IREDELL COUNTY HEALTH DEPARTMENT

IMPROVEMENT PERMIT / AUTHORIZATION TO CONSTRUCT / OPERATION PERMIT / EXISTING SYSTEM INSPECTION

PERMIT# 75141 PIN# 4757 35 2459 DATE 4-18-01

SUBDIVISION BETHANY TRACE BLOCK / SECTION LOT 16 LOT AREA 1.53 SITE CLASS. PS DESIGN FLOW 320 L.T.A.R. .5

INITIAL SITE SKETCH

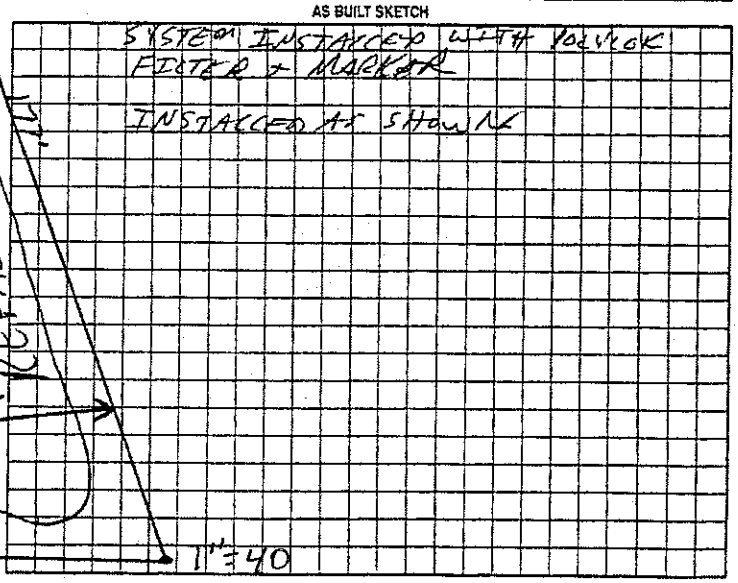
Comments/Conditions: ① Keep system 5' off house, 10' off property line & 15' off top of EMBANKMENT ② KEEP HOUSE 10' FROM SYSTEM ③ INSTALL LINES ON CONTOUR

Location of the proposed 24'x30' BLDG addition does not appear to impact the existing on-site septic system or well.NOTE:**
